# Recall Bulletin

**SUBJECT:** Roof Carrier Retaining Nut Interaction with Roof Rail Airbag

**MODELS:** 2015 Chevrolet Suburban, Tahoe  
2015 GMC Yukon, Yukon XL

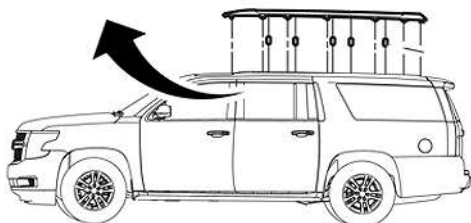
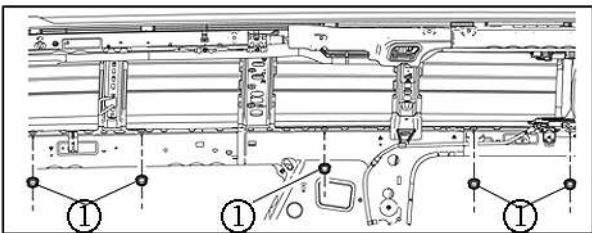
- Removing the assist handles, reading lamps, videos displays then detaching and repositioning upper pillar/quarter trim panels and headliner will allow the necessary access to the side rail fasteners.

1. Remove the luggage carrier side rail retaining nuts (1) from both sides of the vehicle. Refer to *Luggage Carrier Side Rail Replacement* in SI, and only complete the underside fastener removal and install portion of the procedure.

2. Install the new luggage carrier side rail retaining nuts and caps as shown above. Refer to *Luggage Carrier Side Rail Replacement* in SI.

Dealers are to replace all of the roof carrier retaining nuts using a different type of retaining nut and adding a cap over the end of each stud.
